FORD TRACTORS & EQUIPMENT

1982 SERVICE BULLETINS

**Tractors
Equipment**

Service Bulletin

**Figure 1
New Steering Cylinder Piston, SFD 02, 4066T1**

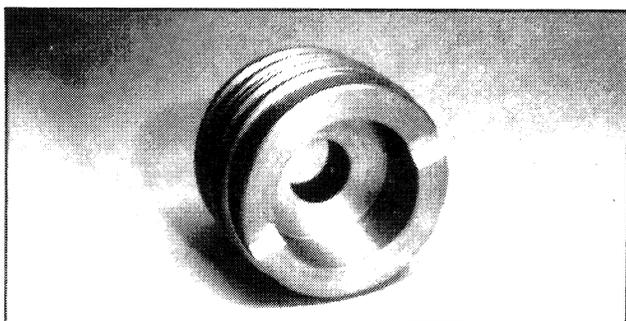
When servicing 4-WD tractor steering cylinders, SFD 01-7774, the base of the cylinders should be inspected for possible deformation or "bulging" where the rod contacts the base. If the base has been deformed, but the cylinder barrel and rod are otherwise serviceable, a new Piston, SFD 02-4066T1, and Seal Kit, SFD 35-1336T1, should be installed.

Installation of the new style Piston, SFD 02-4066T1, Figure 1, will allow the piston to bottom out before the rod, thus distributing the load and eliminating the possibility of additional deformation of the cylinder base.

The above improvements in the steering cylinder have been incorporated in current production tractors.

Figure 3
Push Plate and Wear Pad

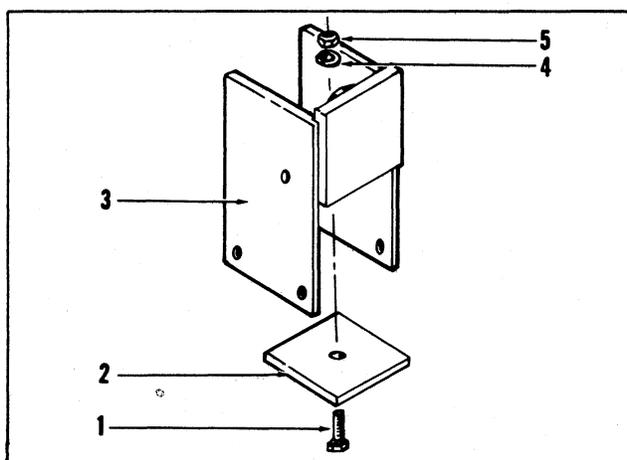
In some instances where the wear pad is bonded to the push plate on the 960 Log splitter, the wear pad has come loose from the push plate and could not be reattached.

have the wear pad bolted to the push plate. This new wear pad, Part No. GB216338, can be adapted to the push plate on models with serial numbers lower and including the above numbers.

To attach the new wear pad, mark the push plate using the wear pad (2), Figure 3, as a template and drill an 11/32" hole. Use a 5/16" - 18 x 7/8" slotted flat head machine screw, a 5/16" - 18 hex nut, and a 5/16" lockwasher to fasten the wear pad to the push plate and tighten securely. The attaching hardware must be procured locally. Grade 5 hardware is preferred.

Figure 1

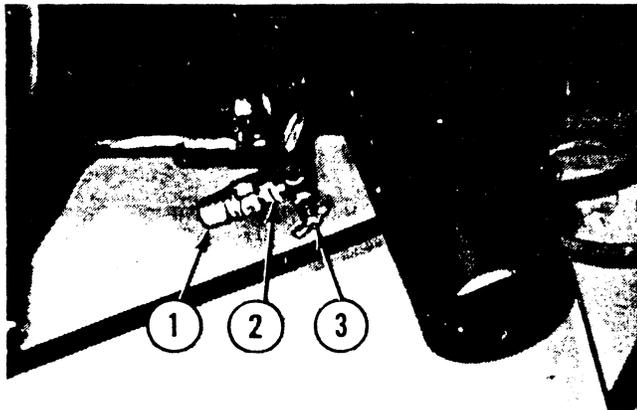
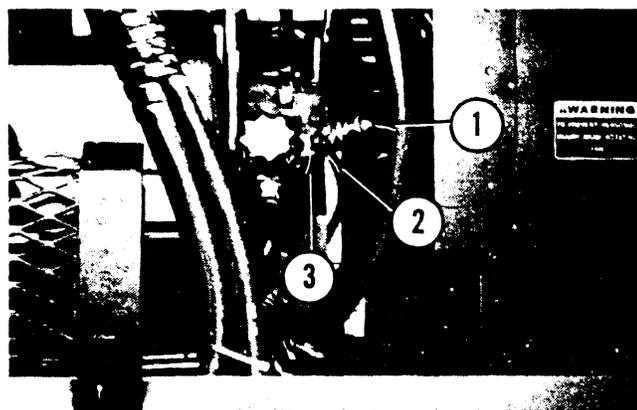
cold weather starting by allowing warm coolant to be transferred to and circulated through the cold engine from a slave unit such as another tractor or service truck that is already running and warmed up. For current service, and for installation of these couplers on earlier production 4WD Tractors, the following parts are available from Parts Distribution:

All 4-WD Tractors currently being shipped have coolant transfer couplers factory installed on the engine. See Figure 1 and 2. The purpose of these couplers is to aid

Part Number	Description	Qty.
SFD-31-1586	Adaptor	1
SFD-31-178	Reducer	2
SFD-50-1172T1	Nipple	2
SFD-31-1574	Nipple	1

Figure 1
Rear Countershaft Bearing Change

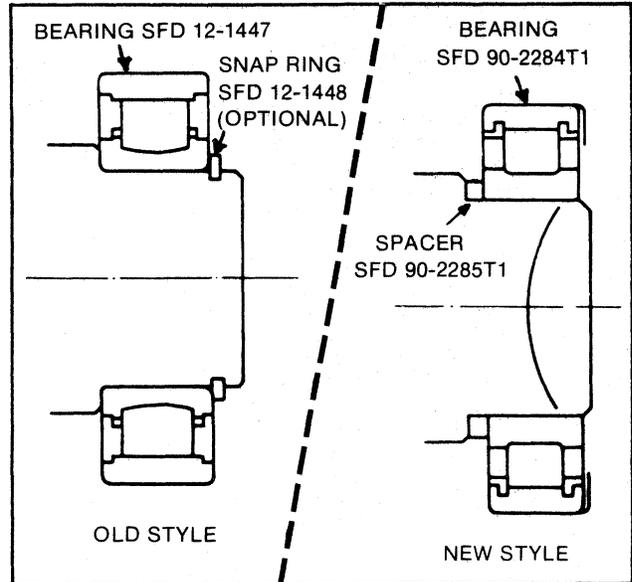
Effective in production in approximately August 1980, a running change was made in the pump drive on the SST 1010 transmission used in FW-20, 30 and 60 Tractors. This change became effective at the following serial numbers:

The lube oil circulating pump is now driven directly off the rear of the left transmission countershaft, whereas, the prior transmission pump drive was located on the bottom left side of the transmission.

***NOTE:** Bearing, SFD 90-2284T1 MUST be used with Spacer, SFD 90-2285T1. Prior Countershaft Bearing, SFD 12-1447 will interchange, but Spacer, SFD 90-2285T1 MUST NOT be used. The rear countershaft snap ring is optional and not required. See Figure 1.

**Figure 2
Gear Shift Linkage**

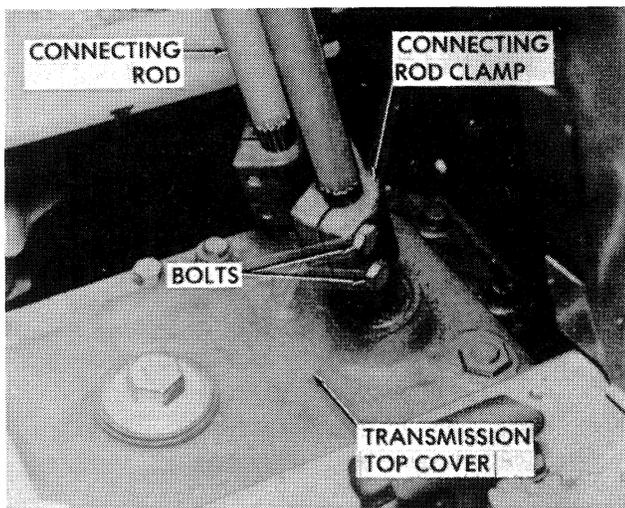
A few cases have been reported where one or both of the gearshift rod clamp bolts shown in Figure 2, have loosened allowing the connecting rods to move out of engagement. To correct this condition, reinstall the connecting rods and adjust them further in or out of the clamp as required to maintain correct gearshift operation. With the rods correctly installed, and with the clamp bolts tightened, the approximate total vertical movement of the shift linkage should be:

Following reinstallation of the connecting rods, operate the tractor in all gears to verify correct installation. Next, tighten the clamp bolts to 42 lbs. ft (56.7 Nm). Finally, scribe reference marks on the connecting rods adjacent to the top of the clamp. These scribe marks will allow correct reassembly following subsequent repairs or overhaul.

Figure 16
Installing Hydraulic Cylinder
Mounting Plate Reinforcement

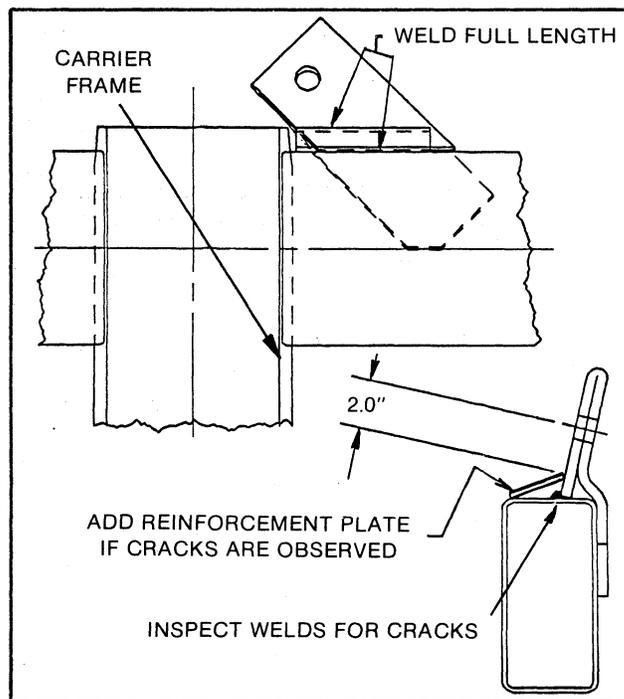
If cracking in the weld surrounding the cylinder mounting plate on the carrier frame is observed on 538 Mower-Conditioners, a locally fabricated reinforcement plate, may be installed as shown in Figure 16.

The new reinforcing plates have been added in production at the following effective points:

Figure 17
Platform Belt Lacing and
Tracking Adjustments

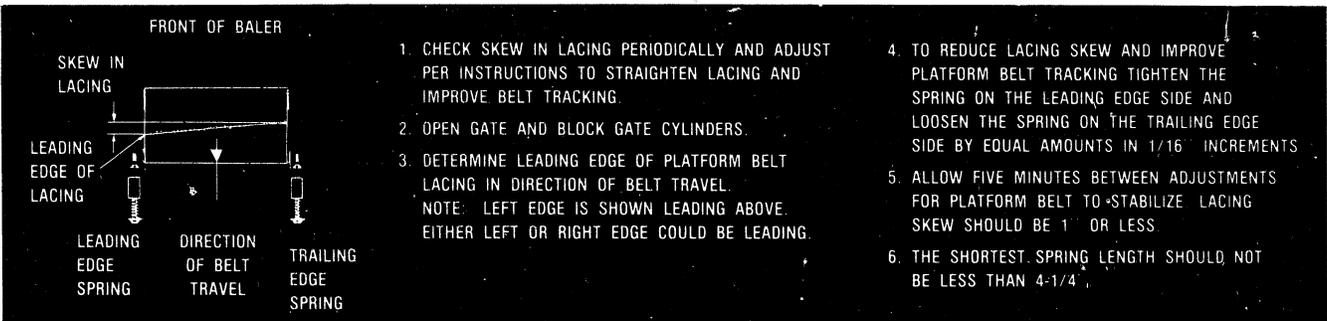
A new decal, P.N. GH-073511, giving detailed instructions for reducing belt skew is now available. Dealers may wish to install these new decals (See Figure 17) on Ford

Figure 18
New Shorter Round Drive Belt

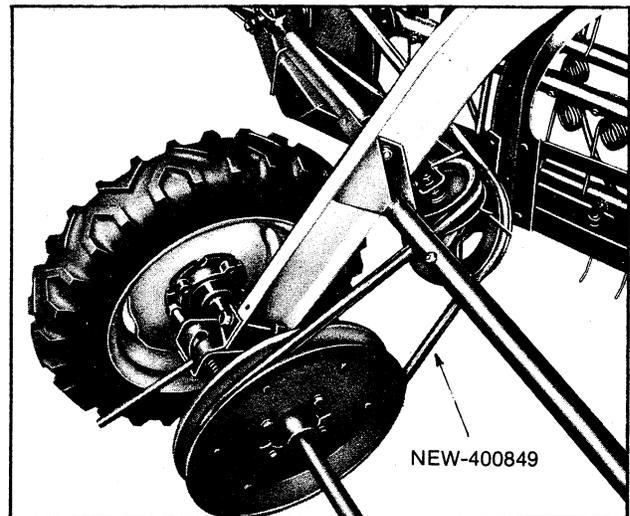
To provide additional tightening capabilities and minimize the possibility of belt loosening and resulting breakage, a new shorter 137" (347.98 cm) round drive belt has been released for use on Series 513 Side Delivery Rakes.

This new belt, NEW-400849, (Figure 18) replaces the longer (141") (358.14 cm) belt, NEW-400194, previously used.
